**FINAL DRAFT  
REPORT**

**Clarksburg - Ten Mile Creek Area  
Sewer Facility Study**

Washington Suburban  
Sanitary Commission

March 2, 2015

- Gravity Trunk Sewers
- Possible Gravity Sewers
- 25ft Contours
- 5ft Contours
- Pulte King
- Egan Mattlyn
- Miles Coppola
- County Owned Parcels
- Clarksburg Historic District
- Stage 4 Area
- Other Properties
- Estimated Buffer Area
- Historic Clarksburg Vicinity Properties

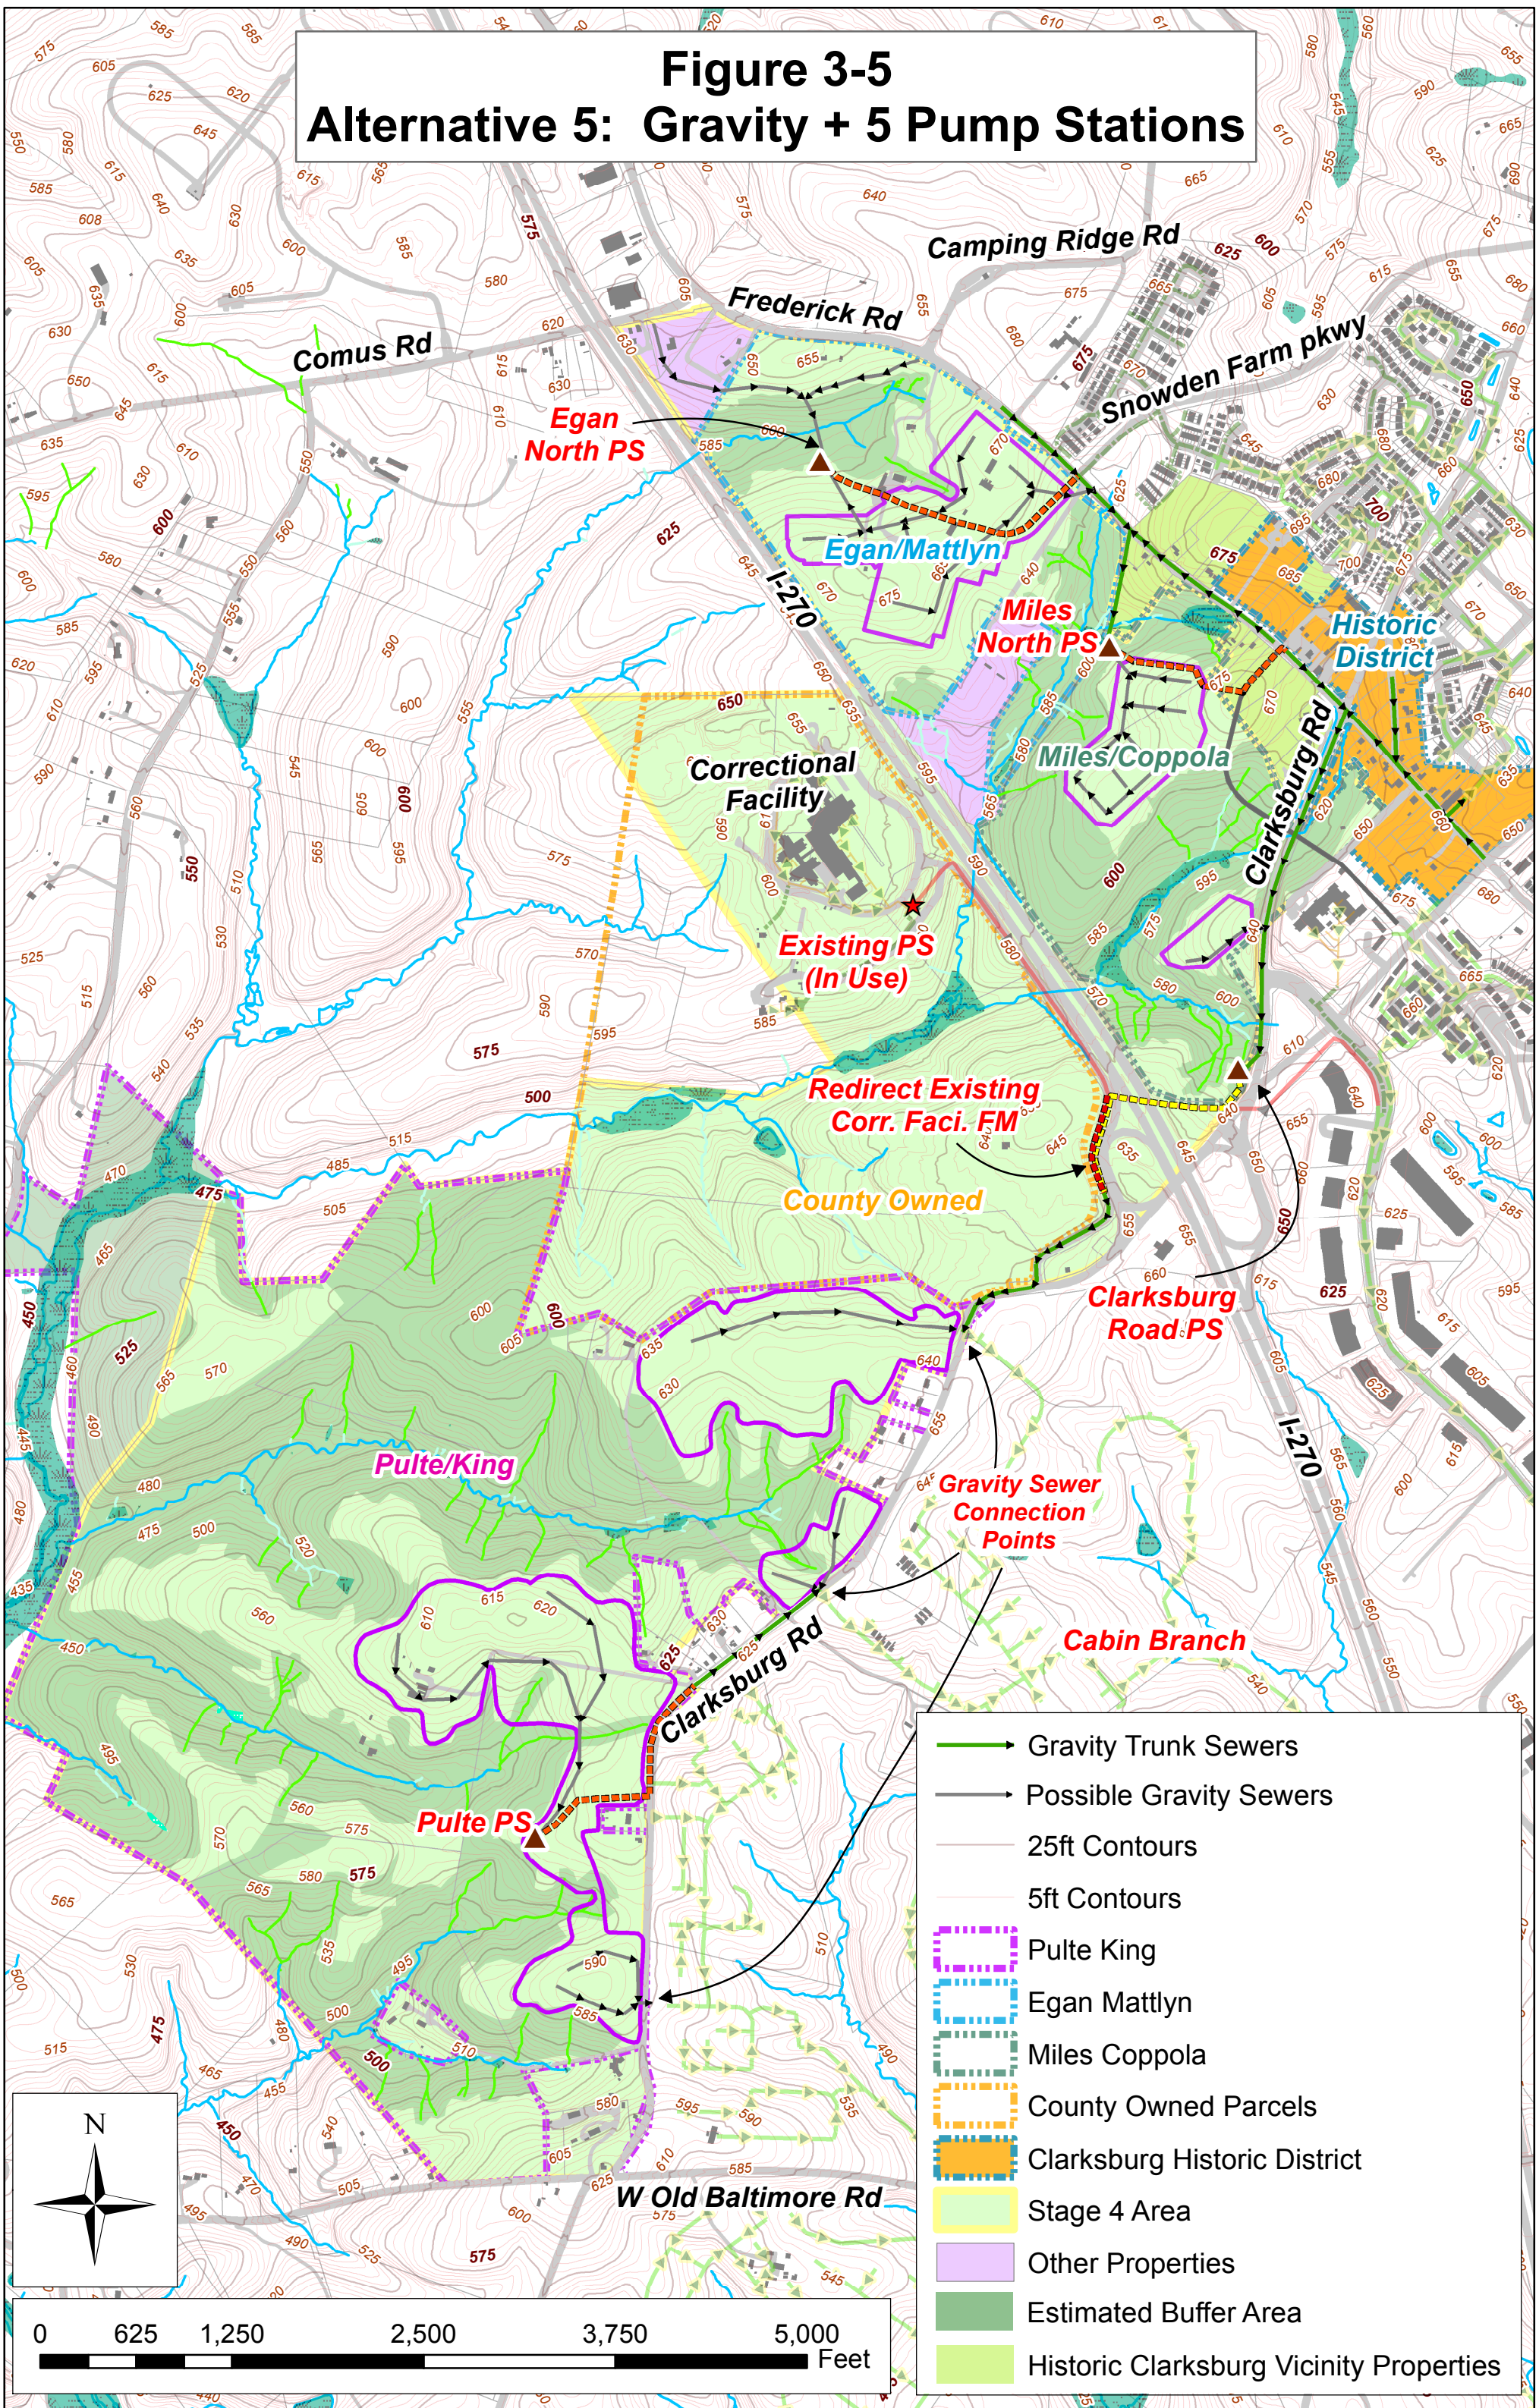
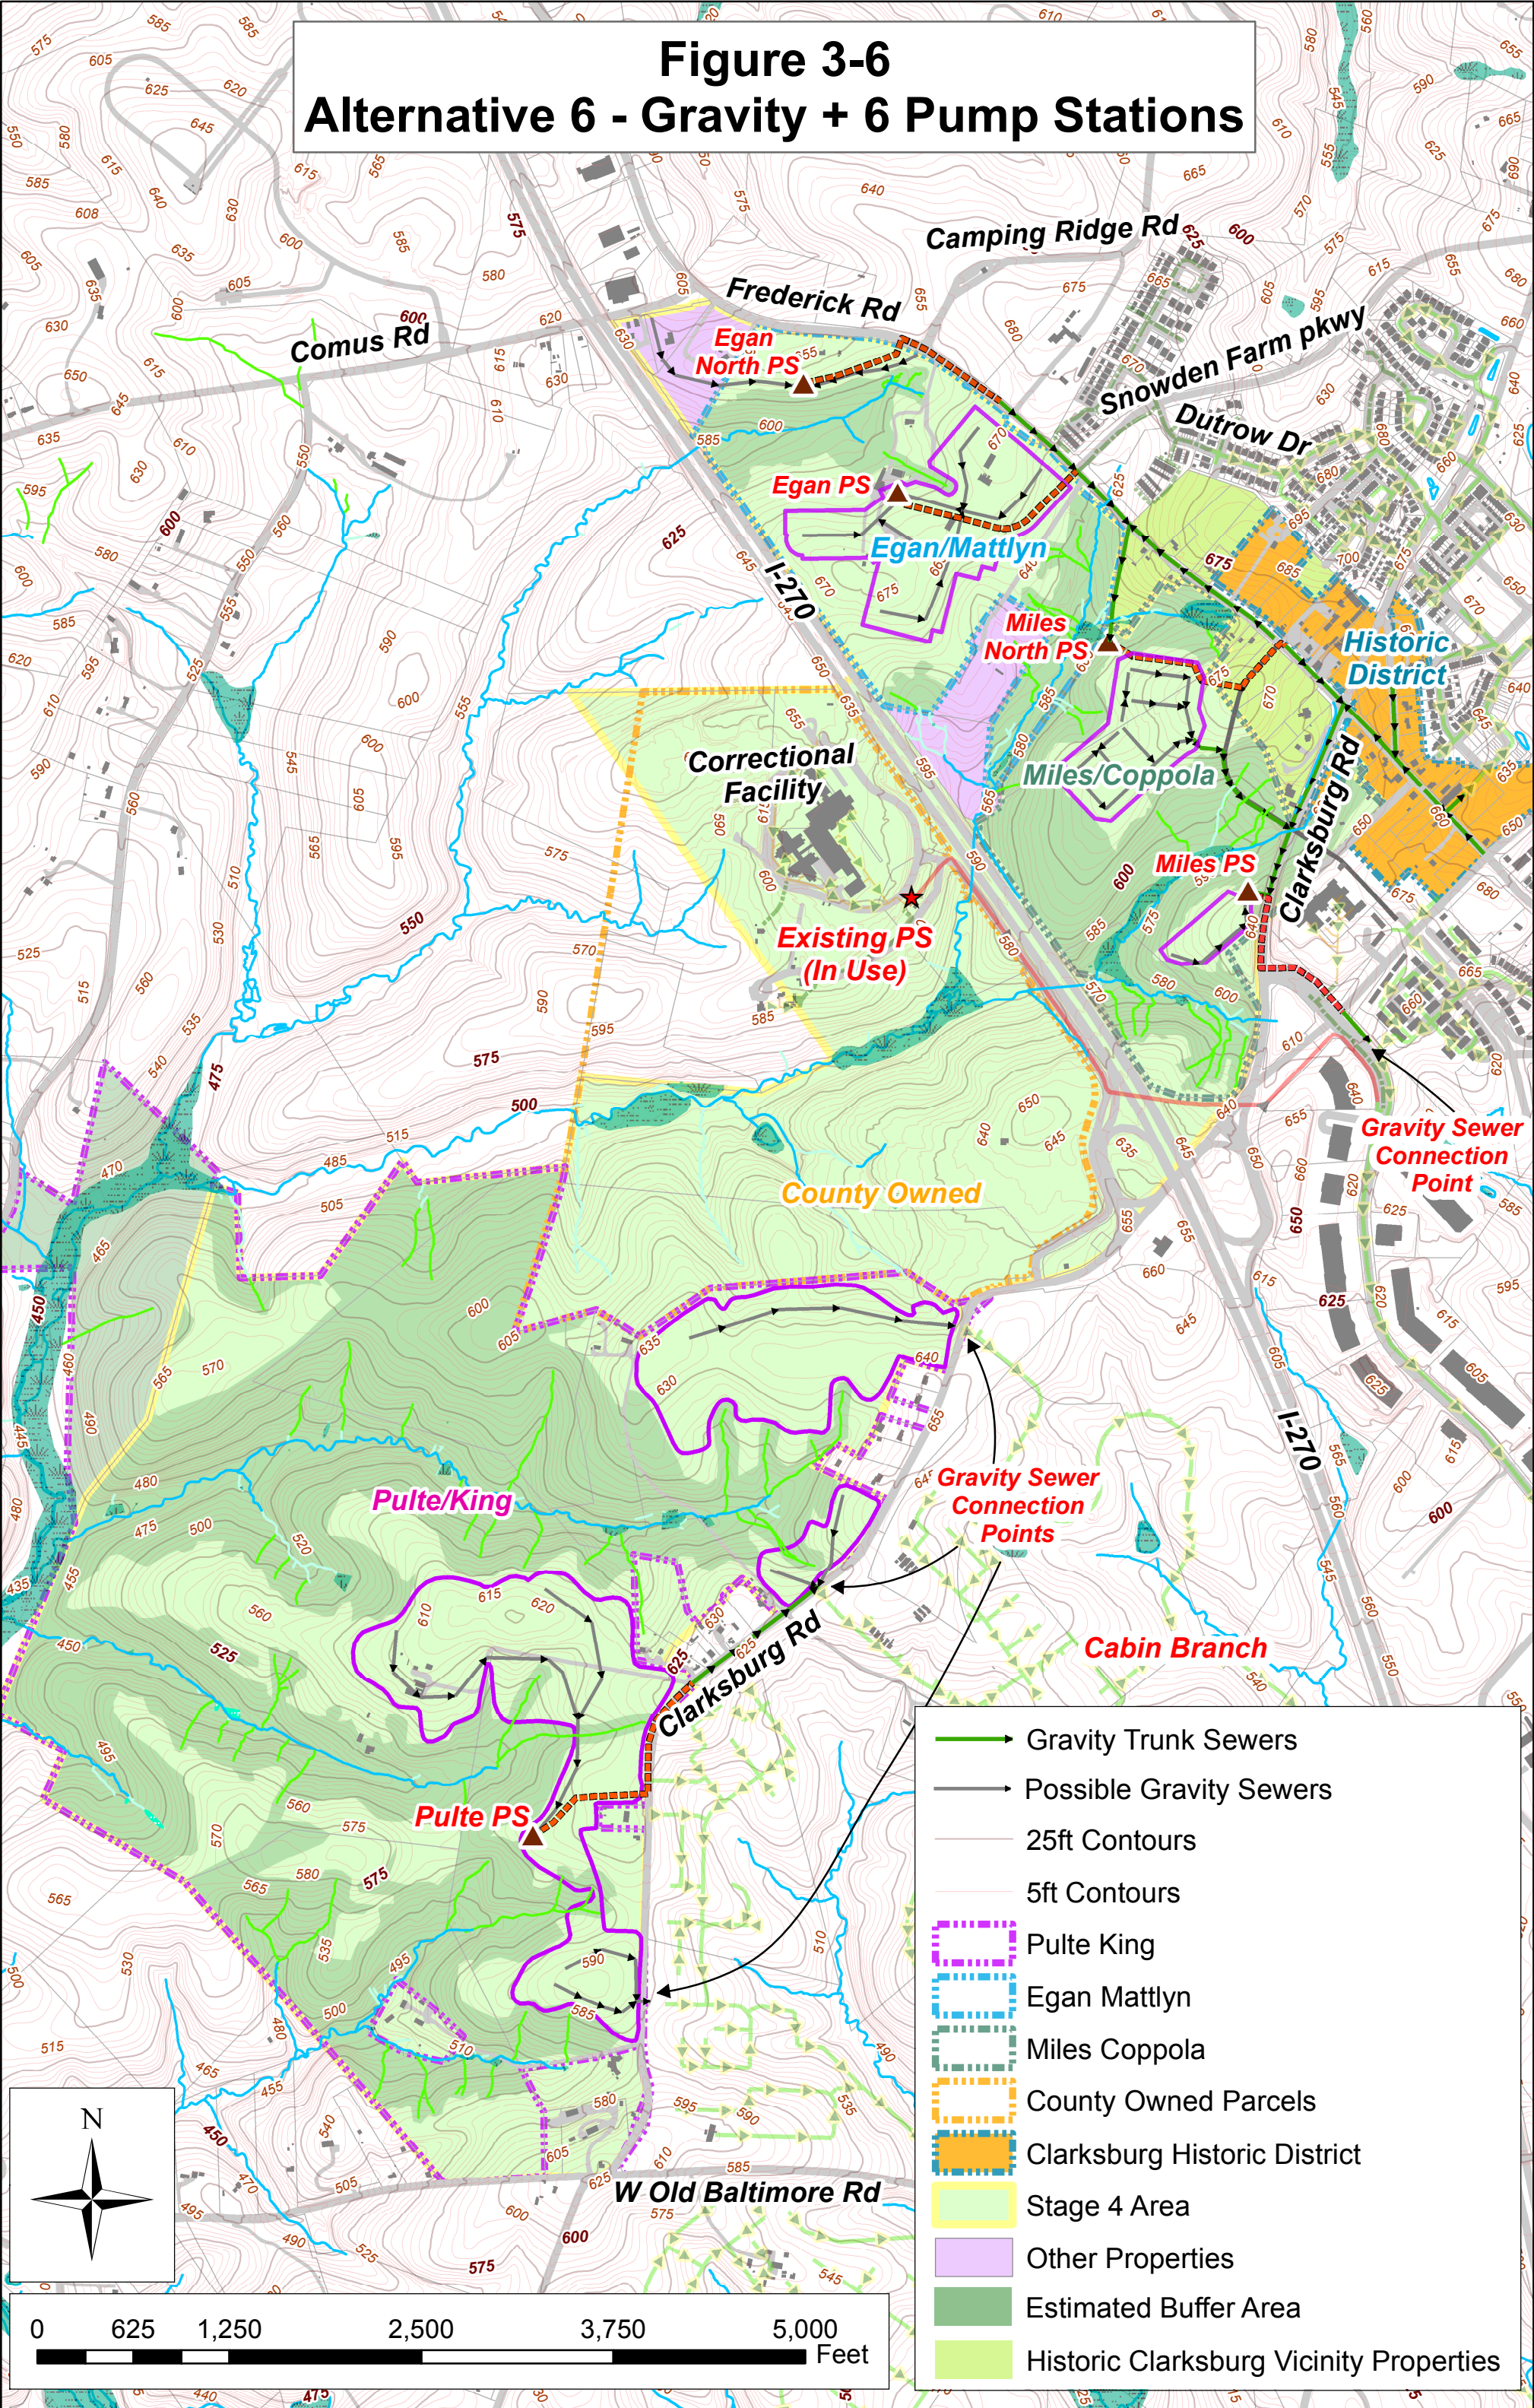
40	12/18/2015	Jay Cinque, Anne James, Cathy Wiss, (CAC Members)	<p><b>5. Remaining sewer issues</b></p> <p><i>c) On the maps for each of the alternatives, sewers in the southern part of the Pulte property appear to stop abruptly. We understand that they will connect to planned sewers in the Cabin Branch watershed that have not yet been built. A notation of this planned connection would be helpful on Figures 1-2, 3-1 through 3-10, 4-3, and 4-4.</i></p>	<p>Revised figures 3-1 through 3-12 in the Final Draft Report to address the comment</p>
41	12/18/2015	Jay Cinque,	<b>5. Remaining sewer issues</b>

<b>46</b>	12/21/2015	Katherine E. Nelson Planner Coordinator M-NCPPC	<i>5. Figures 3-1 through 3-10 (the Alternatives) – These figures identify “Buffer Areas”. Since these buffer areas have not been determined yet, they should be identified as “anticipated” or “estimated” buffers. These figures should also identify all existing and future gravity sewer connection points on the east side of Clarksburg Road.</i>	Revised figures 3-1 through 3-12 in the Final Draft Report to address the comment
<b>47</b>	12/21/2015	Katherine E. Nelson Planner Coordinator M-NCPPC	<i>6. Tables 4-1 through 4-8, pages 4-2 through 4-5 – Long-term operation and maintenance should only include the O&amp;M that will be performed at PUBLIC expense. At the very least, the difference between public and private O&amp;M should be shown. This relates primarily to grinder pumps located in private homes.</i>	Cost tables in Section 4 of the Final Draft report were revised to provide additional clarity. Private capital and O&M expenses and the pump station to be built by WSSC are identified in the revised cost tables. Generally, infrastructure projects need to provide sewer service to a property is built by the developers. Some of these projects may be eligible to receive System Development Charge (SDC) credits. This is determined on a case to case basis. Identifying funding mechanisms for construction of the critical infrastructure needed to serve the entire project area is beyond the scope of this current sewer study. Long term O&M costs for pumping stations is borne by WSSC,

**Figure 4-1  
Comparison of Forcemain Lengths**

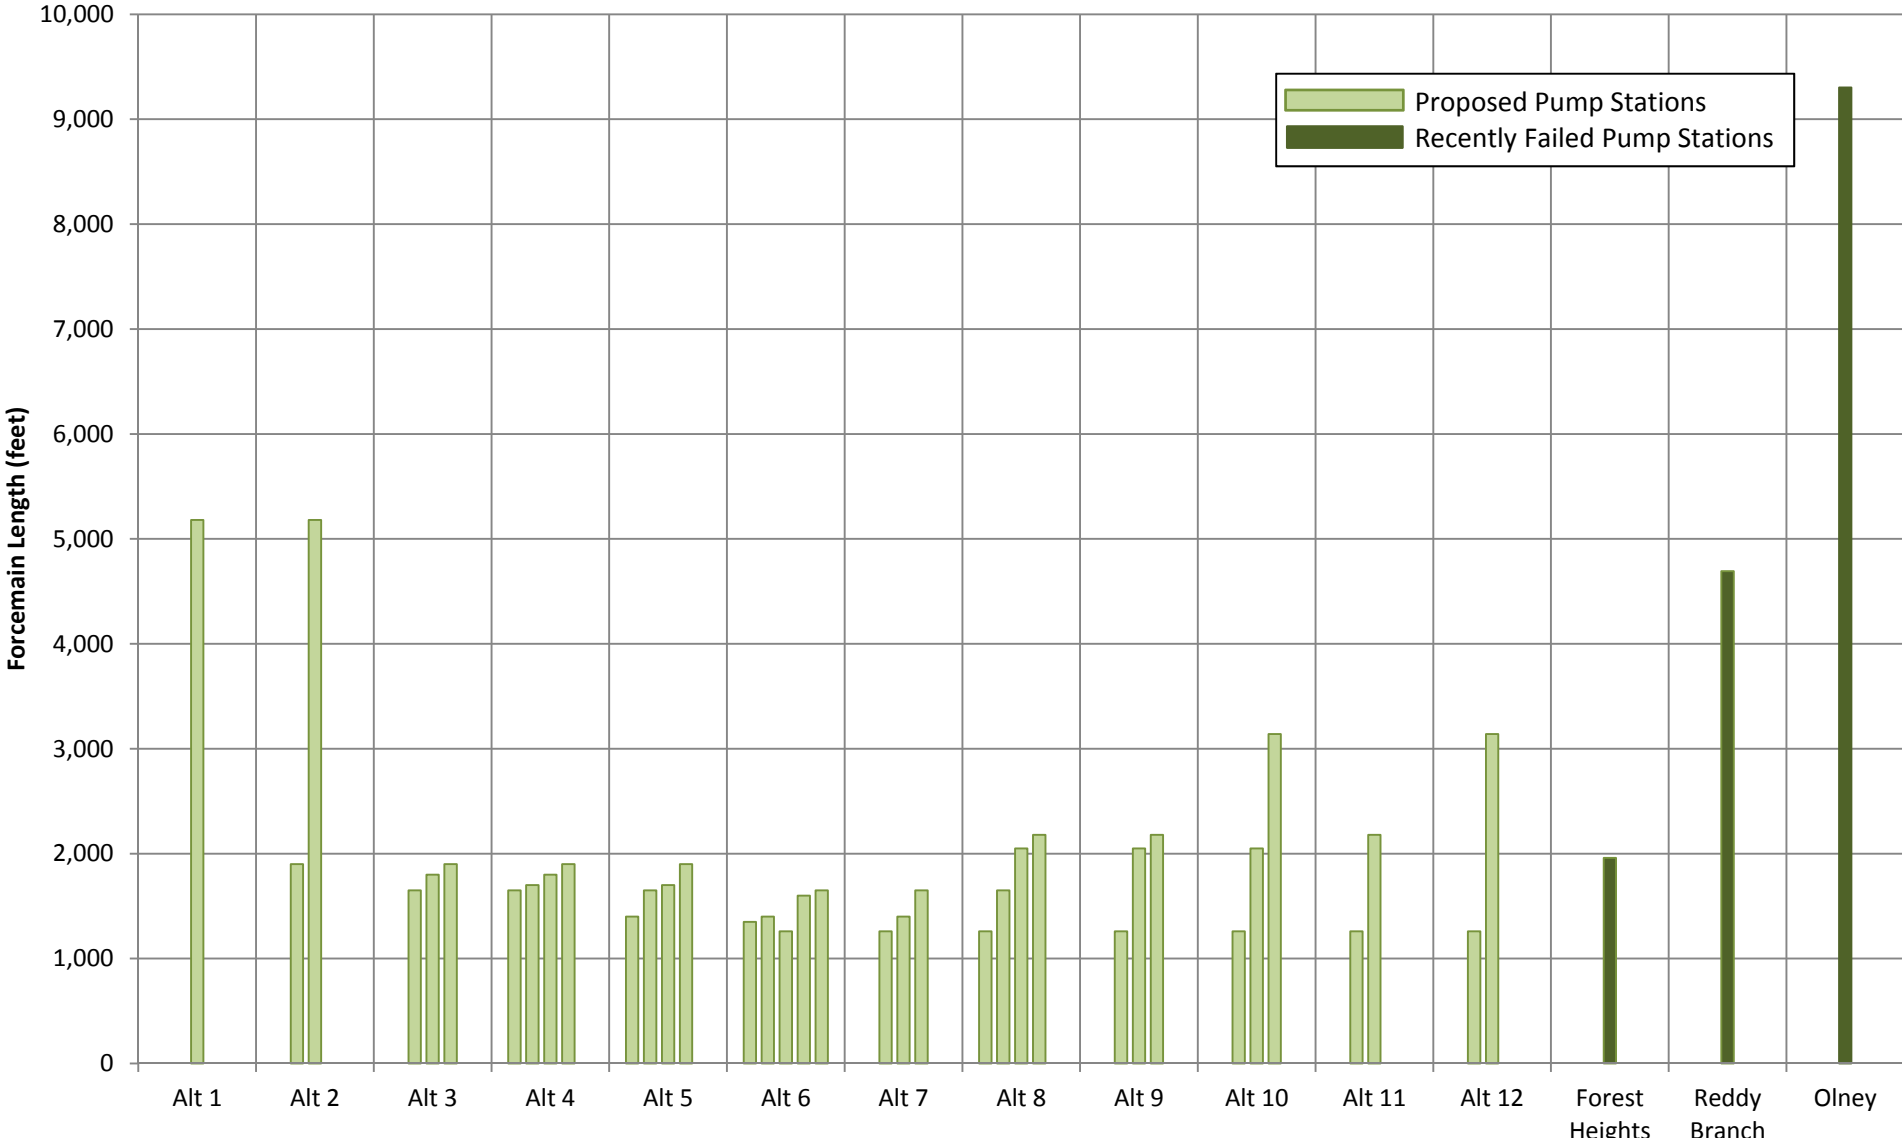
2	12/21/2015	Katherine E. Nelson Planner Coordinator M-NCPPC	<i>11. Figure 4-1 and 4-2 pages 4-14 and 4-15 – Should identify “recently failed” pump stations rather than “existing” pump stations. It implies that these are the only pump stations in the WSSC system.</i>	Revised figures 4-1 and 4-2 in the Final Draft Report to address the comment.
53	12/21/2015	Katherine E. Nelson Planner Coordinator M-NCPPC	<i>12. Figure 4-3 and 4-4 (the Preferred Approaches) – The graphics reference “Grinder Systems” and “grinder pump solution”, but the legend identifies “Low Pressure Sewer”. One term should be used when describing these systems, both on these graphics and in the text.</i>	Revised figures in the Final Draft Report to address the comment.
54	12/21/2015	Katherine E. Nelson Planner Coordinator M-NCPPC	<i>13. Criteria for the successful use of low pressure sewers should be provided by this study. At a minimum, examples of the successful use of low pressure sewers should be provided.</i>	Refer to WSSC SP ENG-04-10, Grinder Systems Policy and Procedure, as to successes we have achieved based on experience and meeting policy requirements.
